**DRAFT FOUNDATION INVESTIGATION AND DESIGN REPORT  
FOR  
PROPOSED PICKEREL AND JACK LAKE ROAD UNDERPASS  
STRUCTURE SITE NO. 44-399  
DISTRICT 52, HUNTSVILLE  
W.P. 473-93-00**

August 5, 1999.  
**Ref. No.: TT98820E**

To: V. Minassian, P. Eng.  
Senior Project Engineer  
Planning and Design, Northern Region

FIGURE NO. 7  
W P 473-93-00

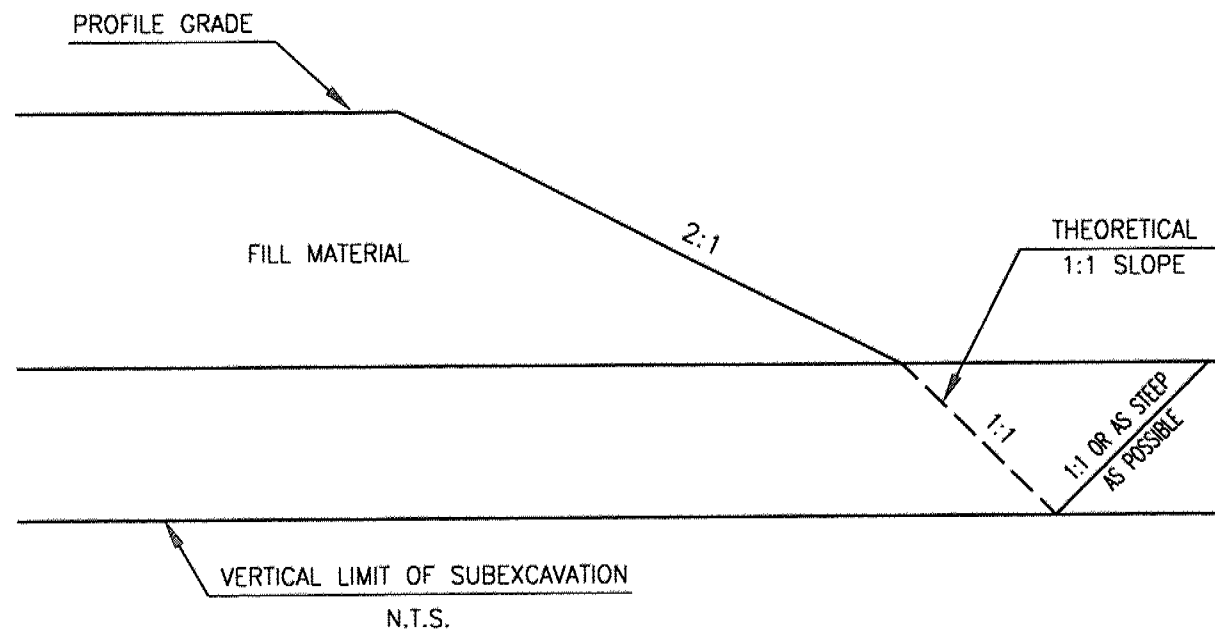
Based on our observation of the behaviour of the soil as illustrated on Figure 7 and as indicated in the report, the soil is of low to intermediate plasticity. Consequently, the soil is not described correctly and should be described as Clayey Silt to Silty Clay.
